Our Ref: **QLD01C0001-LTS-AP-0010**

Information Request Response – APC2023/007 – Change Application for an SDA Approval (APC2022/008) for a material change of use for a medium impact industry (Electrolyser Manufacturing Facility) in the Gladstone State Development Area (SDA)

I write on behalf of the Applicant, Fortescue, please find below a full response to the Information Request required for AP2023/007-SDA sent on 11 April 2024. To assist State Development with the continued assessment of the Change Application we have provided the following details:

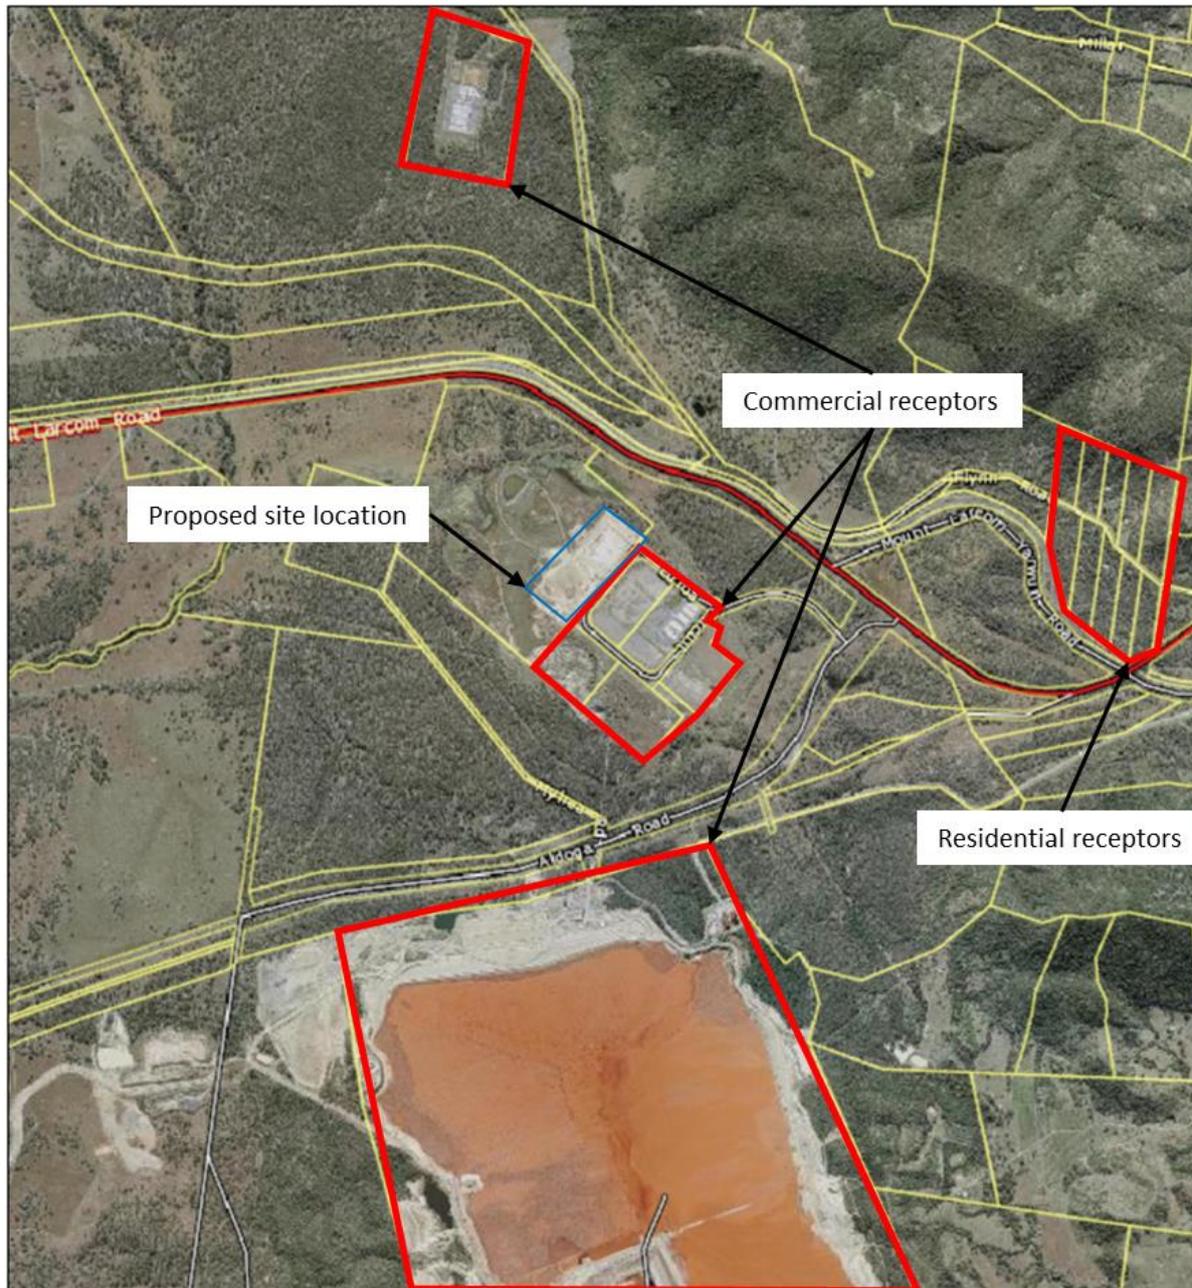
3	Cumulative noise and vibration impacts	<p>It is noted in section 6.1.5.2 – Noise and Vibration, the report states that a noise and vibration assessment has not been undertaken. This appears to be on the grounds that during operational periods, the activity will consist largely of office works and robotic manufacturing which, “do not emit unreasonable noise.”</p> <p>The proponent is requested to provide further information as to</p> <ul style="list-style-type: none"> • how it was determined that the manufacturing process will not ‘emit unreasonable noise’. • as to what ‘unreasonable noise’ was determined to entail and how this was determined to impact the environmental values for the area and relevant acoustic quality objectives for sensitive receptors identified in the Environmental Protection (Noise) Policy 2019.
---	--	---

To determine what unreasonable noise would be a Desktop Noise Assessment has been undertaken against the acoustic quality objectives for sensitive receptors identified in the Environmental Protection (Noise) Policy 2019. The results are below.

The Substantial Change Development will not impact or alter the established electrolyser assembly facility which is housed within a fully enclosed industrial warehouse. Noise source emissions from this approved and certified building are being managed in accordance with the sites operational management plan with the majority of plant items located within enclosures which are either partially closed or fully enclosed.

A high-level review of the equipment proposed for the site identified the air-cooled heat exchangers (ACHE) as the largest noise source. The expected noise of the fans was estimated to be 80dBA at 1m. By applying the inverse square law, the estimated noise level at the boundary (FTS is 75m from the boundary) is expected to be less than 50dBA. Given the Site location these noise volumes will not impact on sensitive uses and would be expected for any new use development in an industrial estate.
